INTERNATIONAL CODE COUNCIL

2015 – 2017 CODE
DEVELOPMENT CYCLE
Group B (2016)

2016 REPORT OF THE COMMITTEE ACTION
HEARINGS ON THE 2015 EDITIONS OF THE GROUP B
INTERNATIONAL CODES

HELD IN LOUISVILLE, KY
APRIL 17, 2016 – APRIL 27 2016

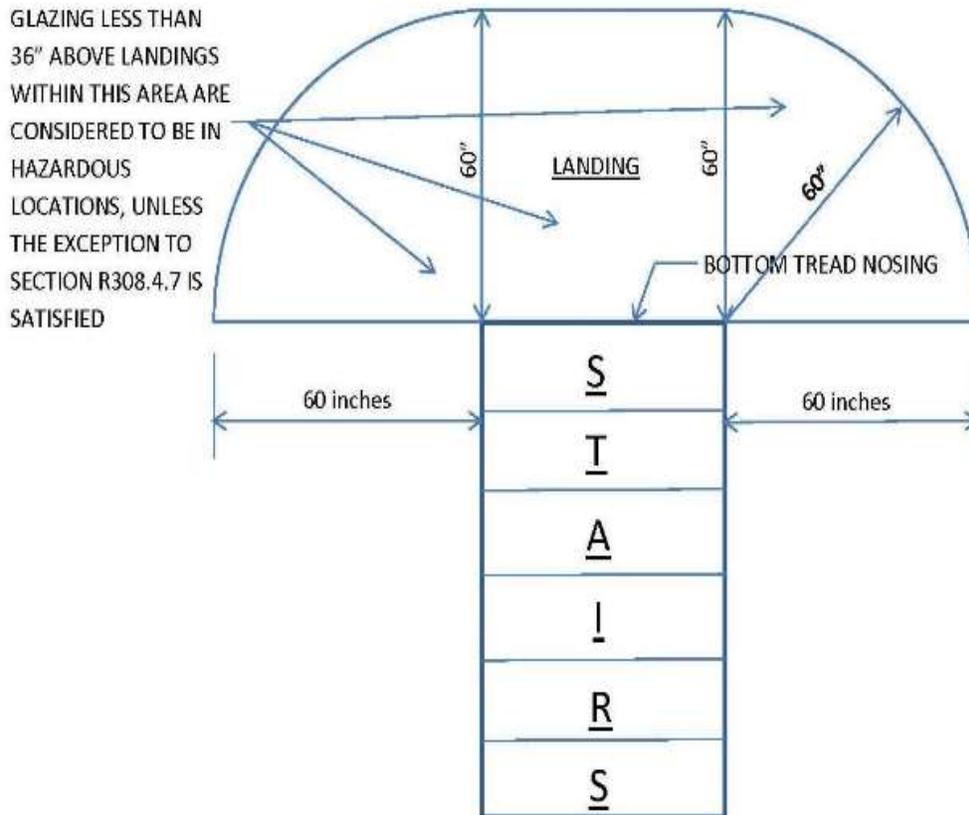
Committee Reason: This proposal cleans up the code and makes it more understandable. By labeling the stairs and landing, the modification further clarifies the intent of the code.

Approved as Modified

Modification:

FIGURE R403.4 (2)
BASEMENT OR CRAWL SPACE WITH PRECAST FOUNDATION WALL ON SPREAD FOOTING

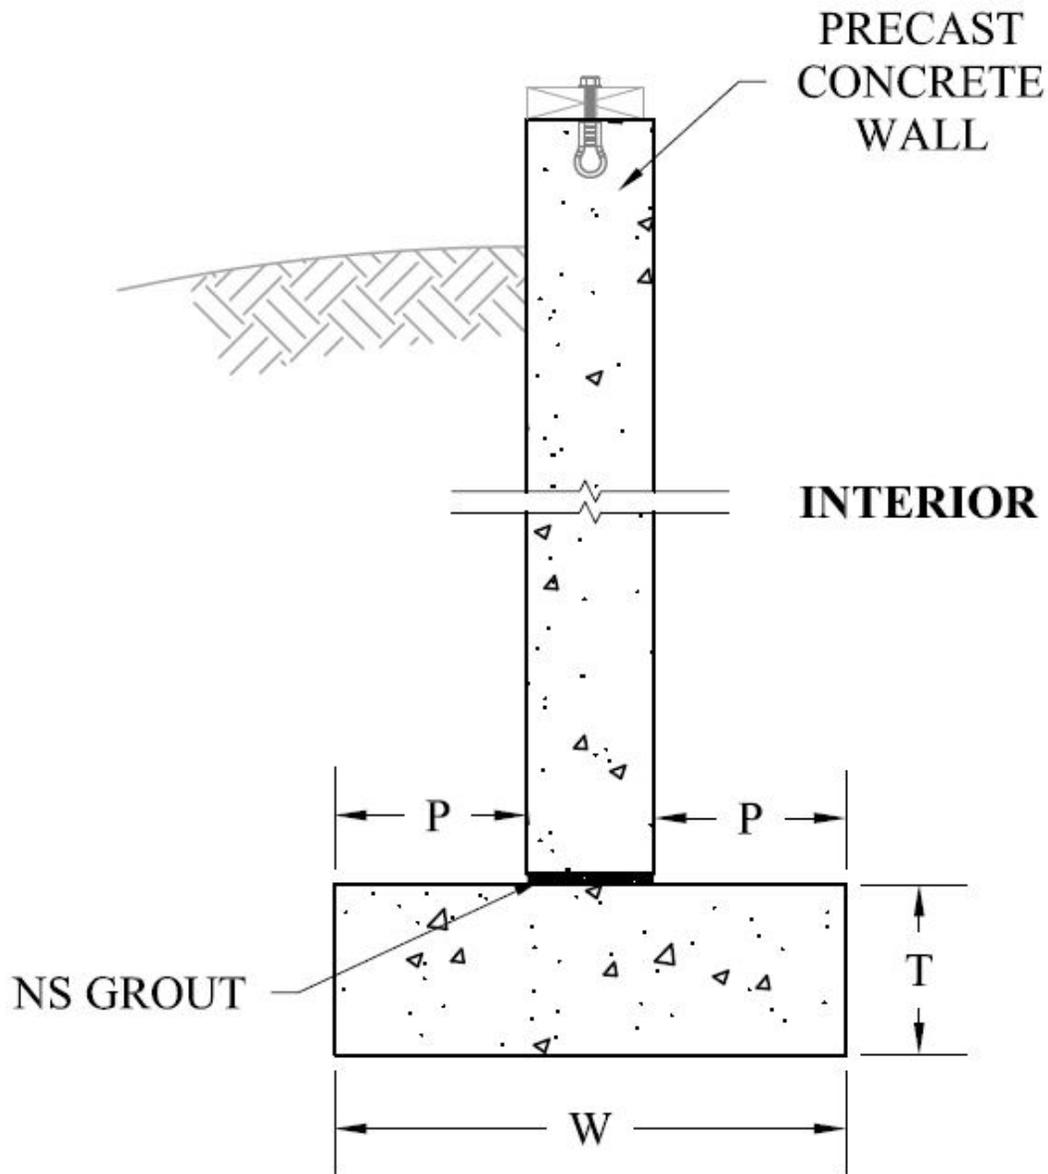
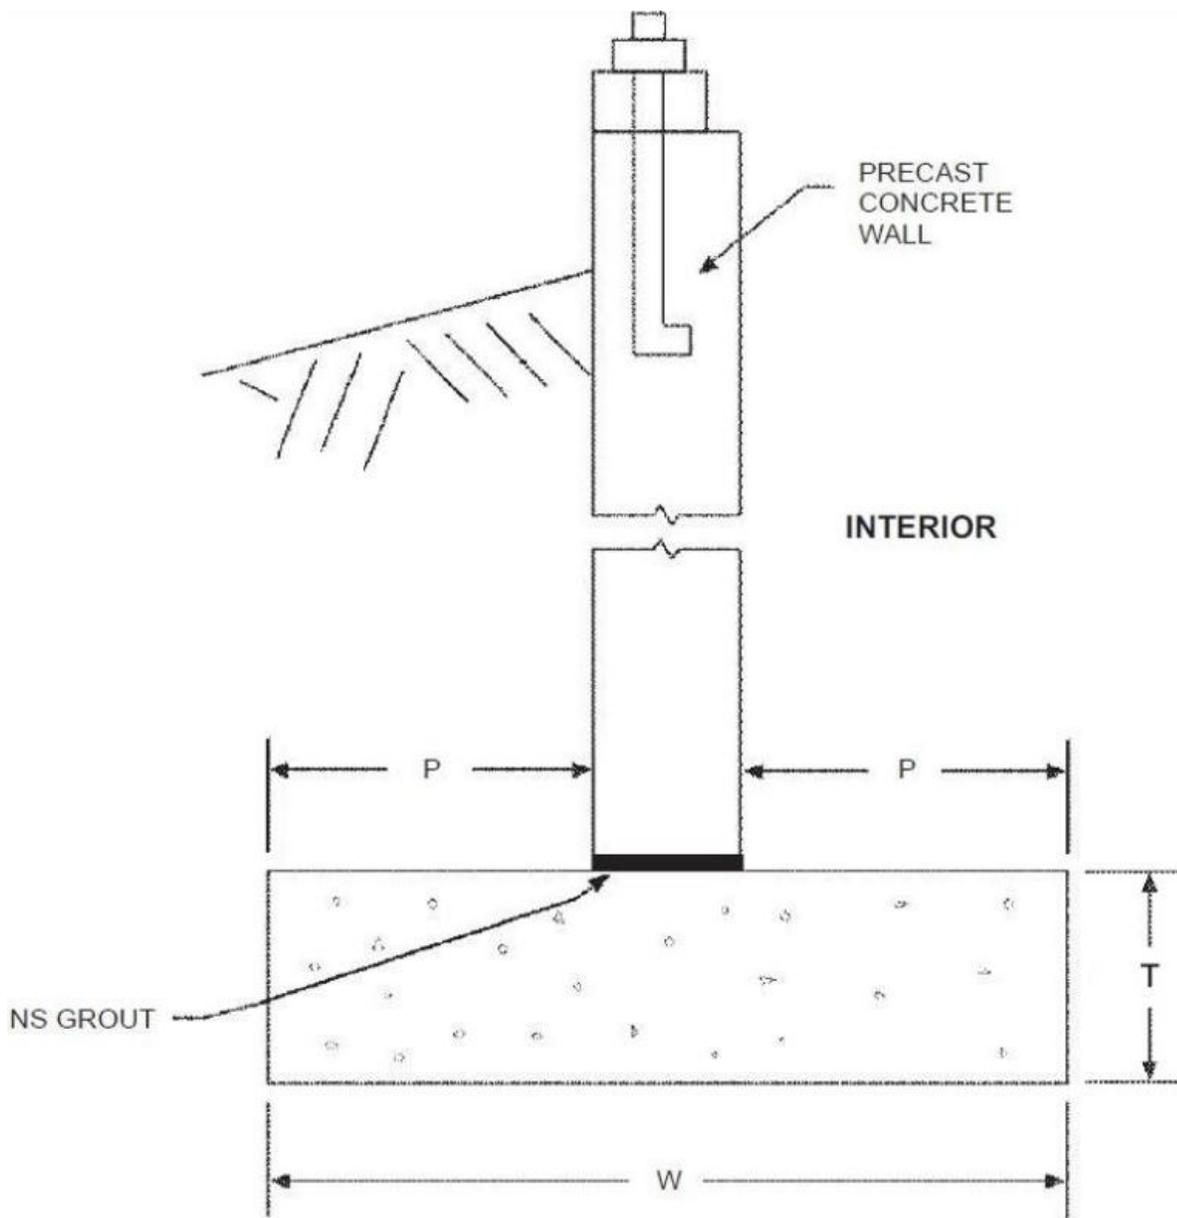
Committee Reason: This proposal updates the figure to add the dimension T for the footing thickness. The modification reverts the figure to the original with dimension T added. The proposed figure was too restrictive.

Committee Action: Approved as Modified

Modification:
